ADDENDUM NO. 2

**PORTER TOWNSHIP ADMINISTRATION BUILDING
Valparaiso, IN 46341**

This Addendum forms a part of and modifies the Bidding Requirements, Contract Forms, Contract Conditions, the Specifications, and the Drawings dated August 25, 2026 by Gibraltar Design, Inc. Acknowledge receipt of the Addendum in the space provided on the Bid Form. Failure to do so may subject the Bidder to disqualification.

This Addendum consists of Pages ADD 2-1 through 2-2 and attached Addendum No. 2 from Gibraltar Design, Inc. dated September 18, 2026 and consisting of 5 pages, Specification Section 08 14 32 - Stile and Rail Wood Doors, Specification Section 33 46 16 - Outlet Structures for Stormwater Ponds, and 15 drawings.

DRAWING
INTERIOR ELEVATIONS

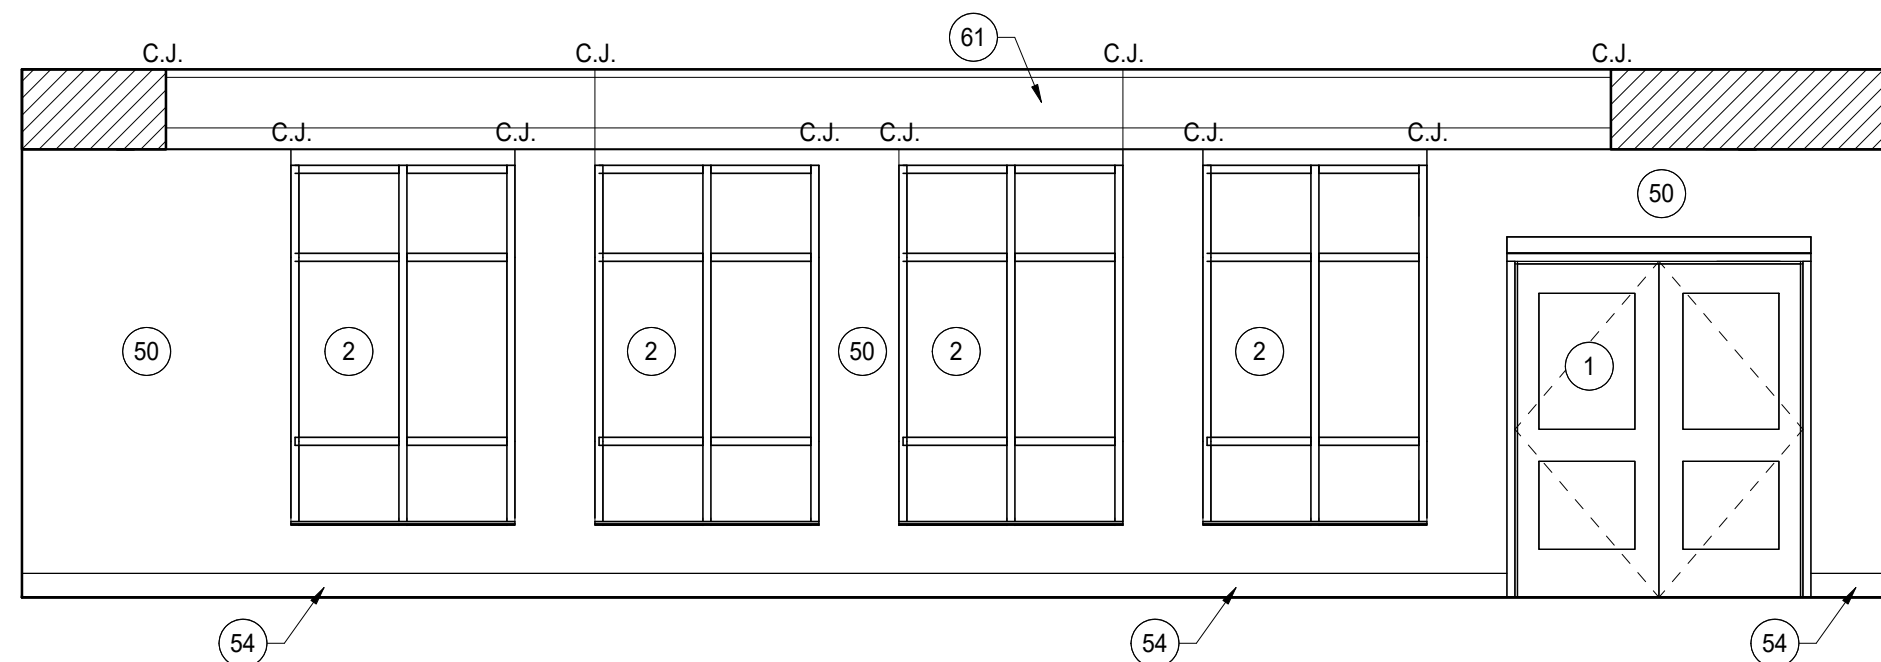
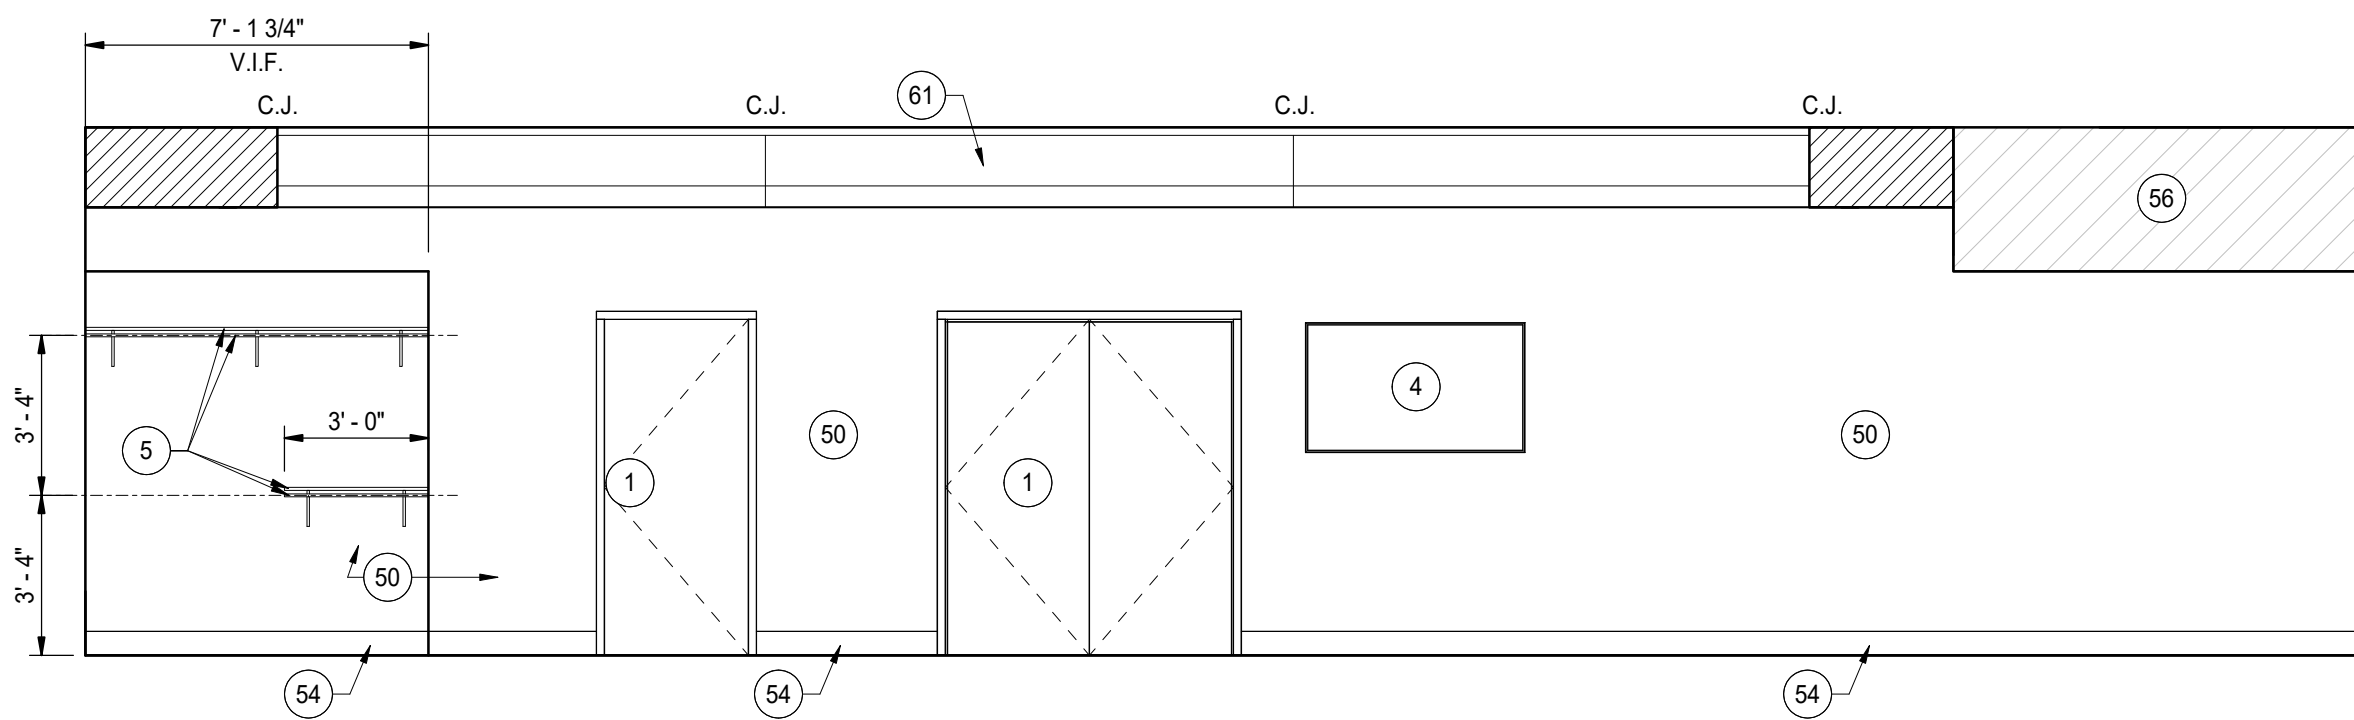
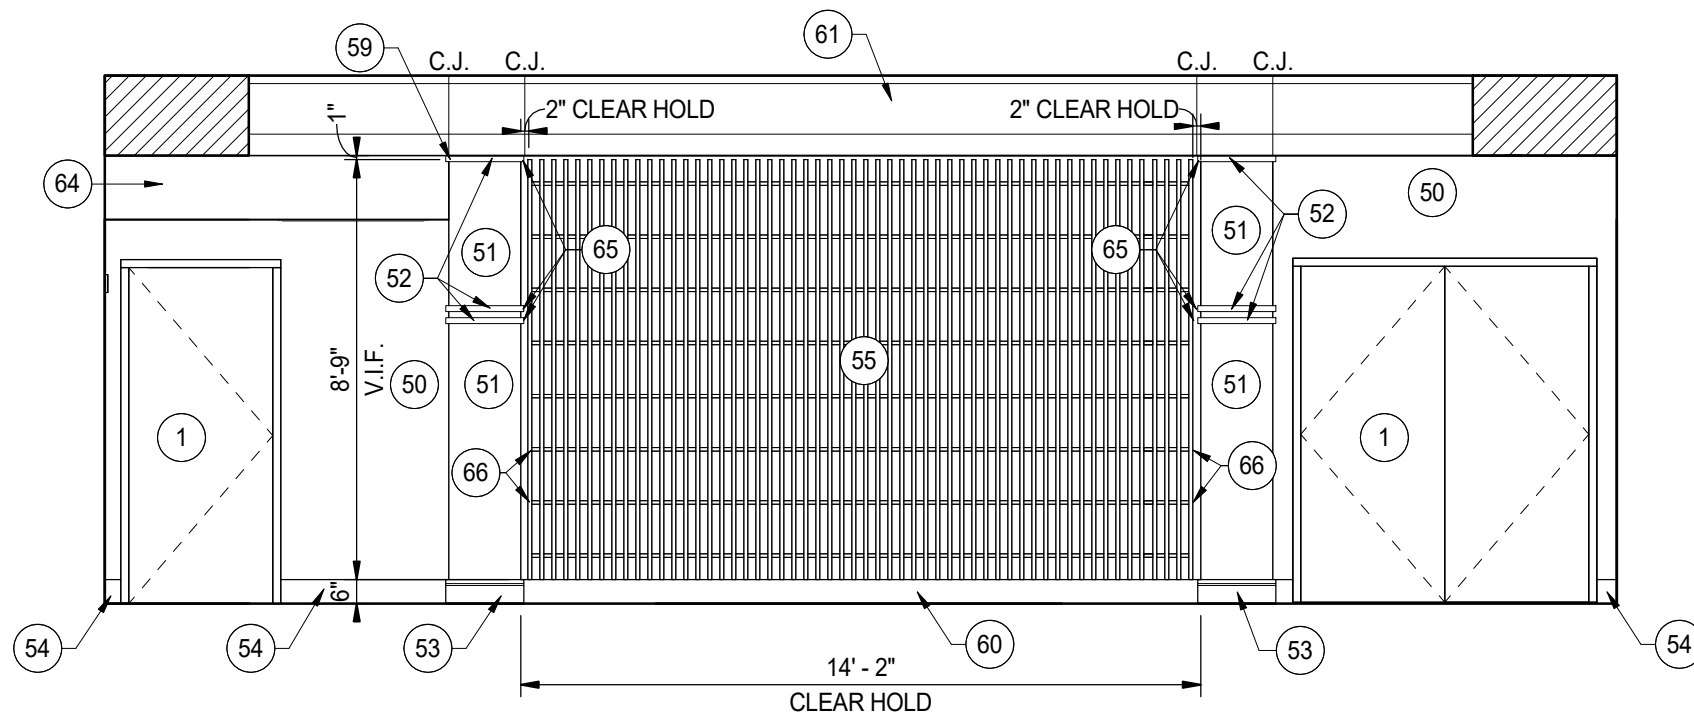
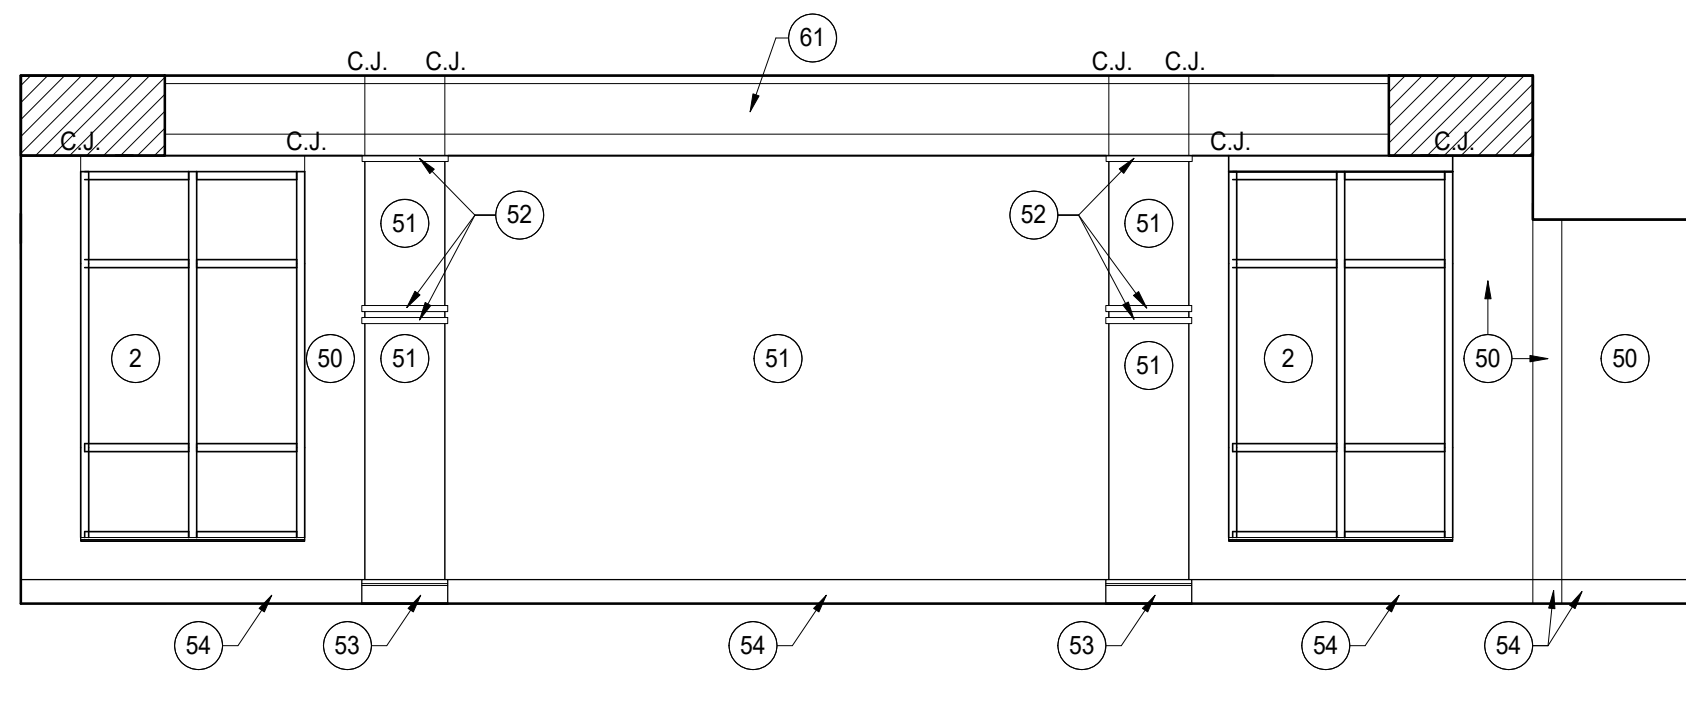
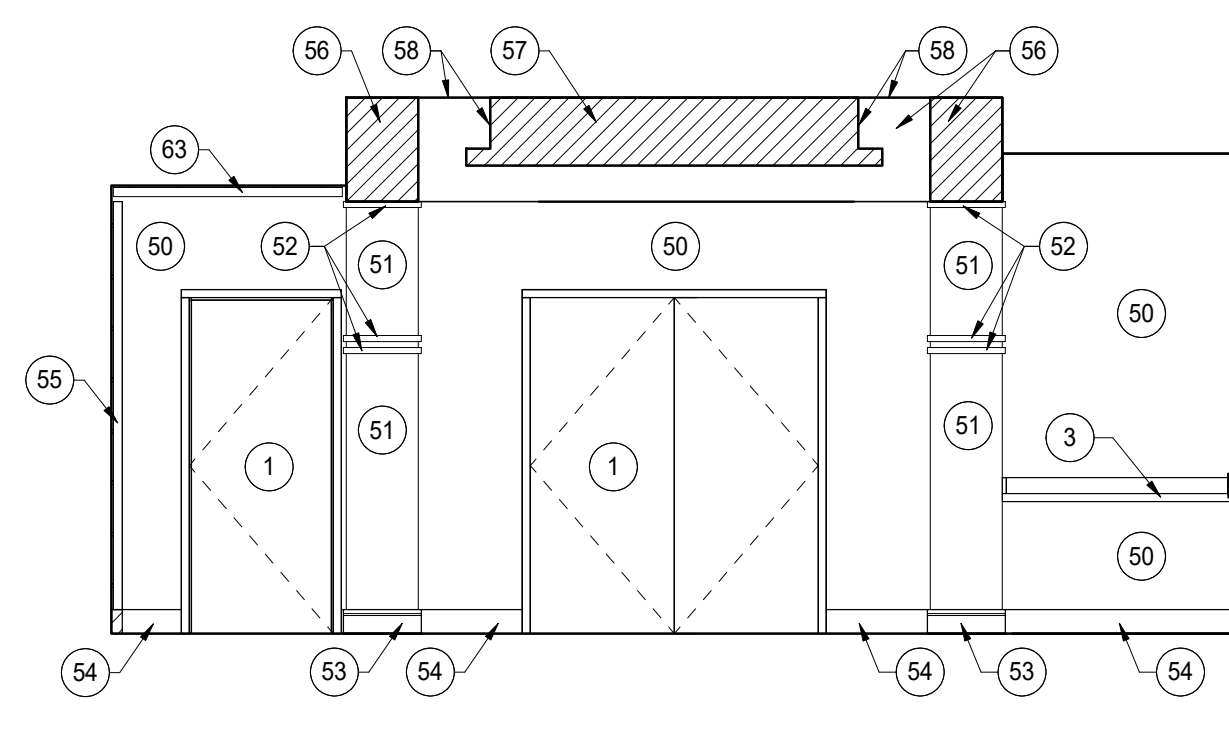
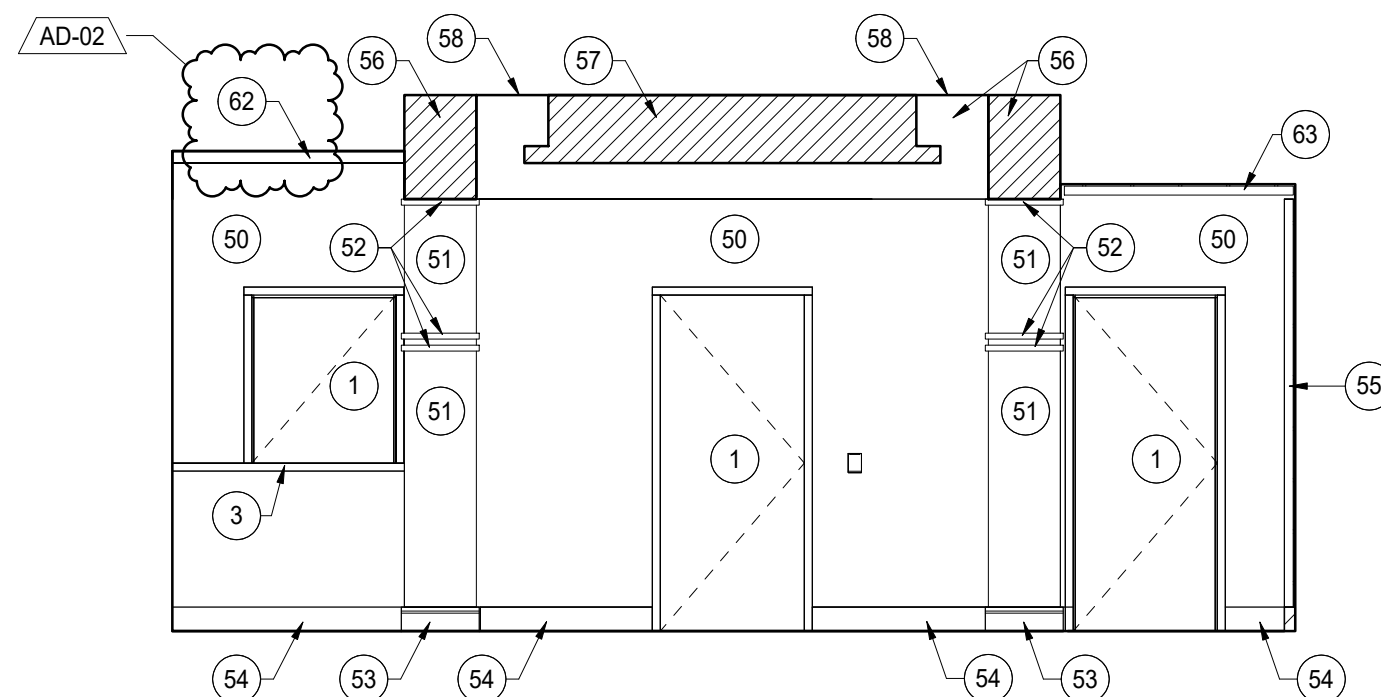
13. Sheet A-860

- A. Refer to revised, full-size drawing, included in this Addendum, for revisions.
 - 1. Interior finish clarifications.
